SD/- (SUNITA MONGA)
CHIEF ARCHITECT
APPROVAL FOR ADDITIONAL
SIGN BOARD

SCALE:- 1/8" = 1'-0"	DATE:-
PARMINDER DEALT BY	JOB No. 1048
CHECKED BY	DRG. No. 35

**ARCH. CONTROL FOR S.C.O IN
NEW CITY CENTRE,
SECTOR-34 (BLOCK 1)**

**GROUND FLOOR PLAN AND
FRONT ELEVATIONS
FOR S.C.O NO. (150,151,152) &
(153,154,155)**

FRONT ELEVATION

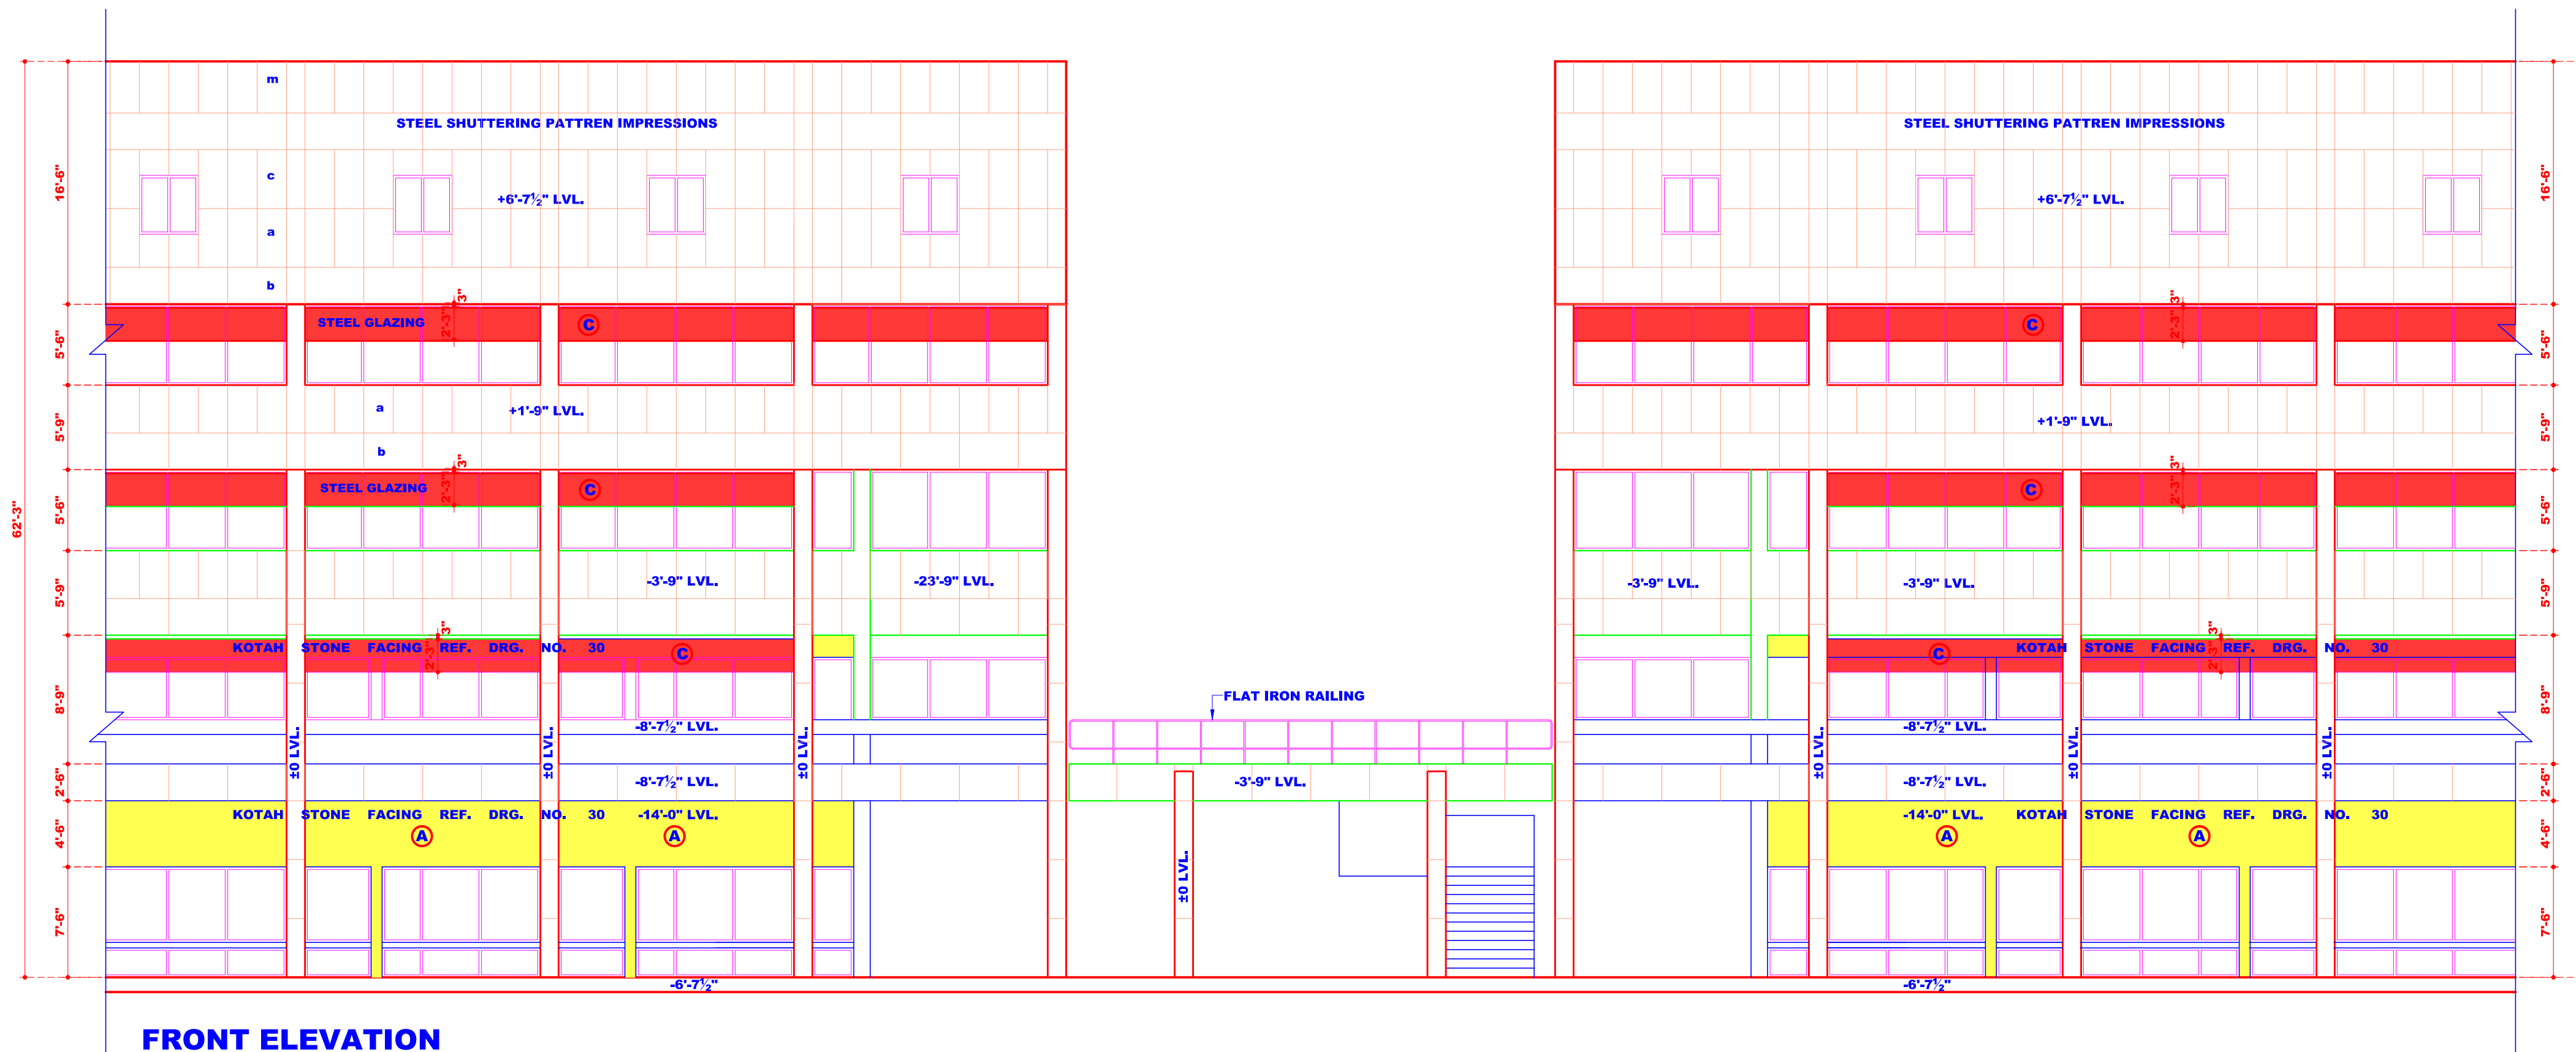
THE ADDITIONAL ADVERTISEMENT PANELS AS SHOWN 'C' ALLOWED ON PAYMENT BASIS SHALL BE PROVIDED AS SEPARATE FABRICATED PANELS IN METAL OR ACRYLIC. THE STRUCTURAL STABILITY AND FIXING OF THE SAME SHALL BE STRICTLY ENSURED AT SITE FOR PUBLIC SAFETY.

IN PURSUANCE TO THE APPROVAL OF THE CHIEF ADMINISTRATOR ON FILE DATED- 16-8-07.

GROUND FLOOR PLAN

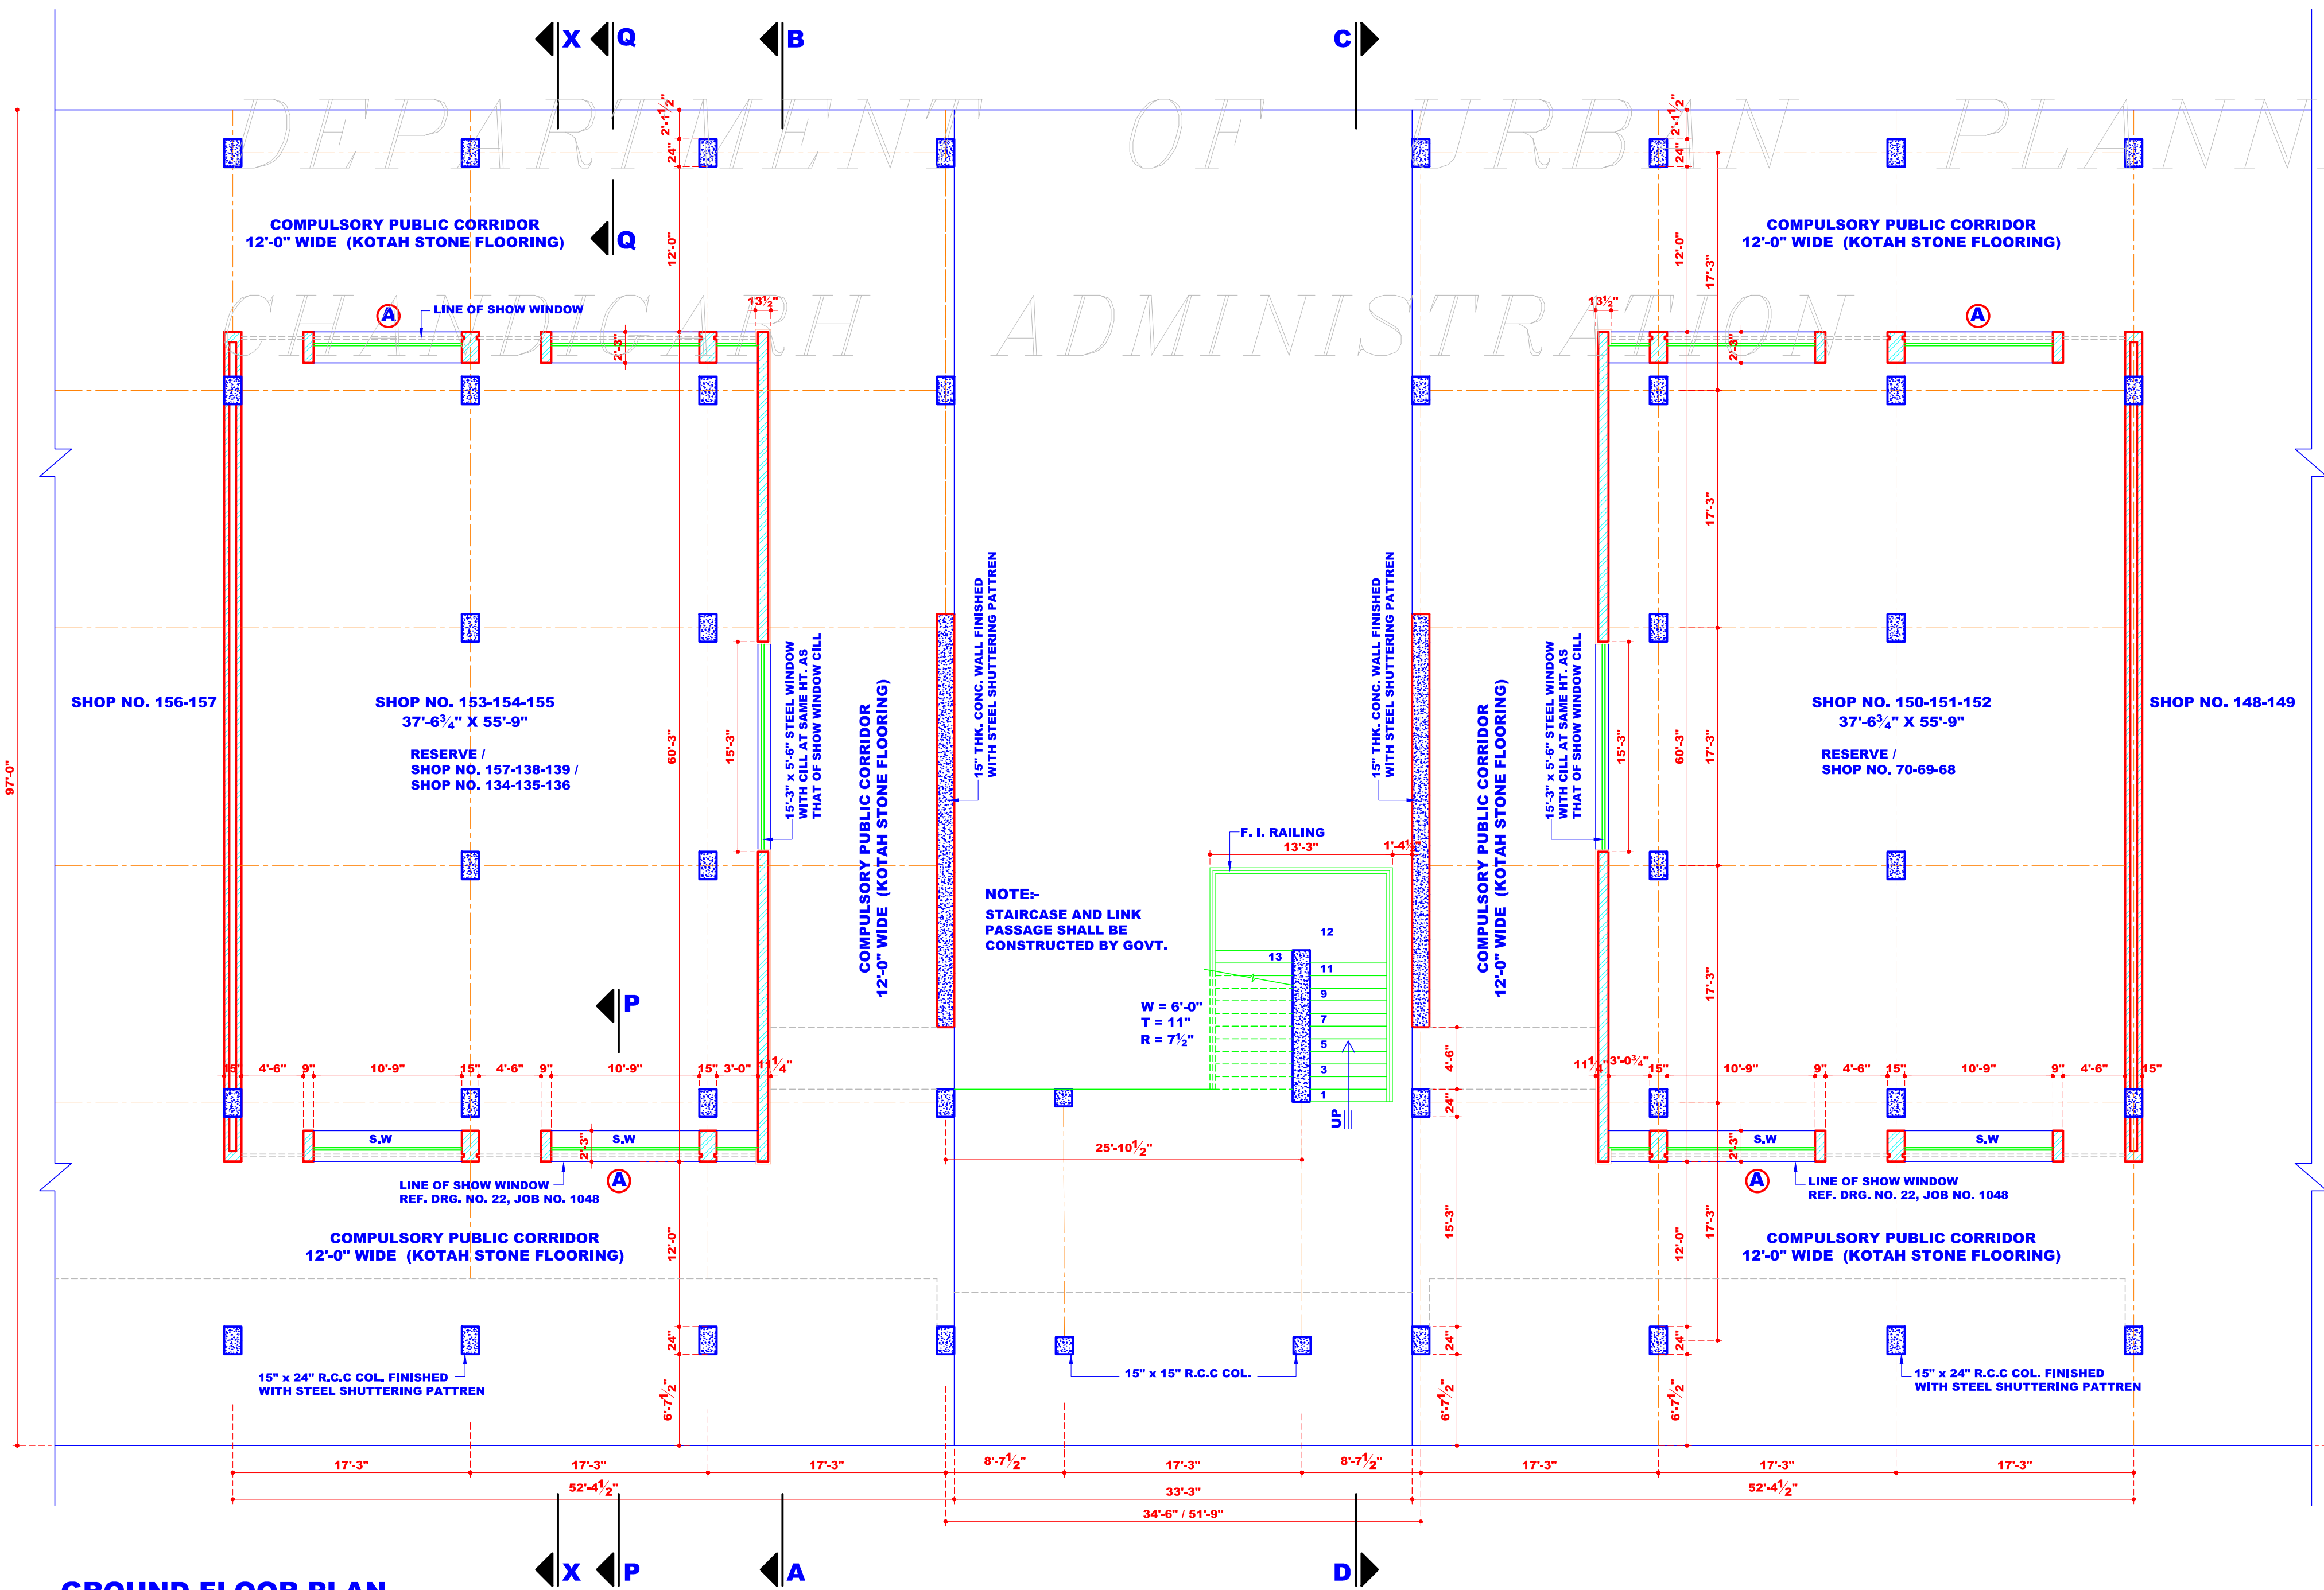
THIS DRG. SHALL ALSO BE APPLICABLE FOR THE DETAIL OF STAIRCASE IN LINK PASSAGE BETWEEN SHOP NO. 137-138-139 & ALSO FOR THE CONTROL OF THESE SHOPS
